Project	IEEE 802.16 Broadband Wireless Access Working Group < http://ieee802.org/16 >	
Title	Action Items from Session #47: Discussion material on inter system communications and system architecture	
Date Submitted	2007-03-15	
Source(s)	David Grandblaise Motorola Labs Parc Les Algorithmes Commune de Saint Aubin 91193 Gif sur Yvette, France	Voice: +33 (0)1 6935 2582 Fax: +33 (0)1 6935 4801 mailto: david.grandblaise@motorola.com
Re:	Working Group Letter Ballot #24a for IEEE P80216h/D2	
Abstract	This contribution tries to bring together the inter-system communications issues and system architecture issues. The contribution provides some preliminary material for discussing the relevance of both backhaul and over the air inter systems communications in the light of the current (or revised) system architecture.	
Purpose	Discuss backhaul based, over the air based inter system communications vs. system architecture

Action Item from Session # 47: Discussion material on inter- system communications and system architecture

Figure 2: Coexistence architecture

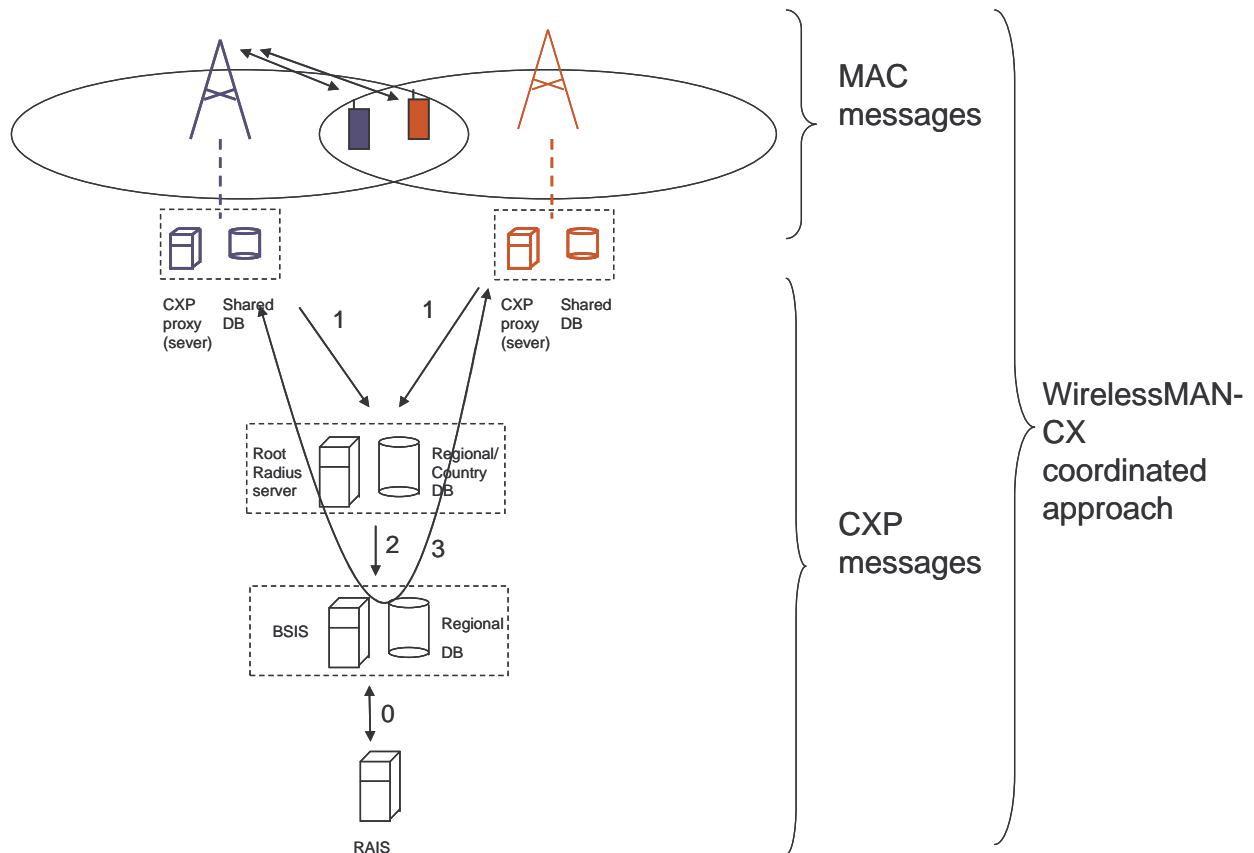
D2 currently consider a coexistence architecture (Figure 1) composed of the following elements:

- at the BS level: CXP proxy + shared DB
- within the network (Country/regional level): Root Radius server/ Country/regional DB
- within the network (regional level): BSIS (administrated by the Service Provider)/Regional DB.
- within the network (regional level): RAIS (National Radio Administration) – no DB
- within the network (regional country/level): centralized server (it seems to be BSIS’s centralized server !?)

Problem: unavailability or unreliability of the IP network prevents/stops WirelessMAN-CS operations. Maybe more critical for inter-operators situation ?

Problem: Are the DB single or multiple operators? Which information is confidential or not? How is the CXP impacted in the inter-operators case?

Problem: It seems the BSIS/Radius and CMI/CSI substitute one another. Text for Radius server is not well developed.

Problem: it seems centralised DB = BSIS's DB, and distributed DB = shared DB

Problem: no DB is associated with RAIS

Problem: where should regulatory related information should be handled?

Solution: define an over the air inter BS communication safe mode including simplified CXP messages. But which messages of Table 2 should be conveyed over the air?

Solution: TBD

Solution: Maybe, consider just one technique (CMI/CSI) and remove Radius server ?

Solution: if centralized DB is considered, centralized DB could have a role (or any other) as proposed in the comment below. If centralized DB not relevant, remove centralized DB.

Solution: if Radius remains, its related regional/country DB could be common with RAIS's one.

Solution: RAIS server and country/regional DB instructs BSIS server/BSIS's DB
